Agenda Item # 6

SUB-003149-2024

Resubdivision of Lots 1-4 & 13-15, Grimes & Winbush Subdivision

RESUBDIVISION OF LOTS 1-4 & 13-15, GRIMES & WINBUSH SUBDIVISION

DETAIL SITE PLAN

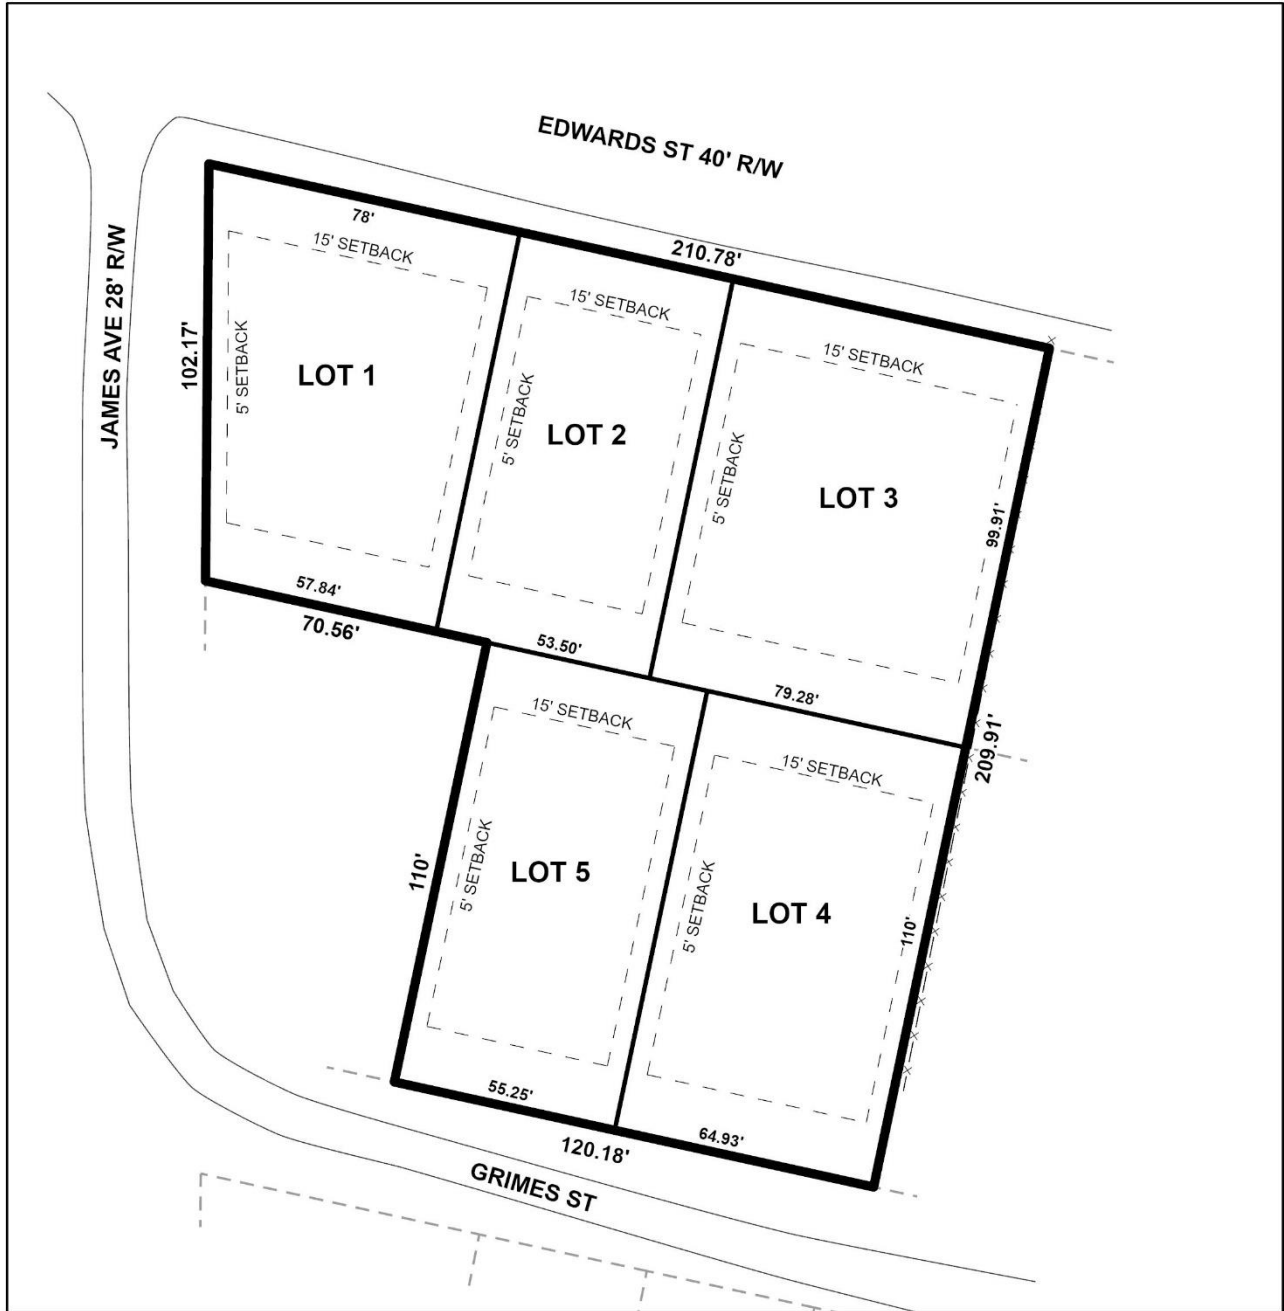
Proposed Lot 1 has frontage on James Avenue and Edwards Street, Lots 2 and 3 have frontage on Edwards Street, and proposed Lots 4 and 5 have frontage on Grime Street, all of which are minor streets without curb and gutter requiring 60-foot right-of-way widths. Substandard right-of-way widths are depicted along each street. As such, if approved, the plat should be revised to illustrate dedication sufficient to provide 30 feet from the centerline of each street, unless a waiver of Section 6.B.9. of the Subdivision Regulations is recommended by the City Engineer and Traffic Engineer.

Lot 1 is a corner lot requiring a 25-foot radius where Edwards Street and James Avenue intersect, per Section 6.C.6. of the Subdivision Regulations. If approved, revision of the plat should be required to illustrate sufficient dedication of the corner radius unless a waiver of Section 6.C.6. if recommended by the City Engineer and Traffic Engineer.

Grimes Street is incorrectly labeled as "Edwards Street" on the preliminary plat. If approved, the plat should be revised to correctly label Grimes Street.

The lots, as proposed, exceed the minimum size requirements for lots served by public water and sanitary sewer in an R-1, Single-Family Residential Urban District, but are not labeled in either square feet or acres on the preliminary plat, as required by Section 5.A.2(e)(4) of the Subdivision Regulations. If approved, revision of the Final Plat to provide the size of each lot in both square feet and acres should be required, adjusted for any required dedication; or provision of a table on the Final Plat with the same information will suffice.

A 15-foot front yard setback is illustrated along each street, but only a 5-foot front yard setback is required for lots in the R-1, Single-Family Residential Urban District, per Article 2 Section 64-2-5.E. of the Unified Development Code (UDC). The applicant may retain the 15-foot setbacks, but if approved and the plat recorded in Mobile County Probate Court depicts a 15-foot front yard setback, future development of the properties will be subject to a front yard setback that is greater than what is required by the UDC. As such, at least a 5-foot front yard setback should be illustrated along each street on the Final Plat, if approved, adjusted for any required dedication.

Five (5)-foot side yard setbacks and fifteen (15)-foot rear yard setbacks are illustrated along side and rear property lines, which is not required by the Subdivision Regulations. As such, if approved, removal of the side and rear setbacks from the Final Plat should be required.

1. Revision of the plat to illustrate dedication sufficient to provide 30 feet from the centerlines of Edwards Street, James Avenue, and Grimes Street, unless a waiver of Section 6.B.9. of the Subdivision Regulations is approved;

2. Revision of the plat to illustrate dedication of a 25-foot corner radius on Lot 1 where Edwards Street and James Avenue intersect, unless a waiver of Section 6.C.6. of the Subdivision Regulations is approved;

3. Revision of the plat to correctly label Grimes Street;
4. Revision of the plat to label each lot with its size in square feet and acres, or provision of a table on the Final Plat with the same information, adjusted for any required dedication;

5. Retention of at least a 5-foot front yard setback along each street frontage, adjusted for any required dedication;
6. Removal of the side and rear yard setbacks from the Final Plat;
